# LINOTYPE IMPROVEMENT SHEET

NO. 320

# MICRO-THERM ADJUSTABLE RELAY HEEL SPRING ATTACHMENT (F-9046)

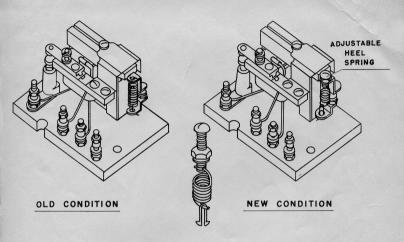
A Micro-Therm Adjustable Relay Heel Spring Attachment has been designed to control the adjustment of the spring tension to insure the opening of the Relay under all conditions.
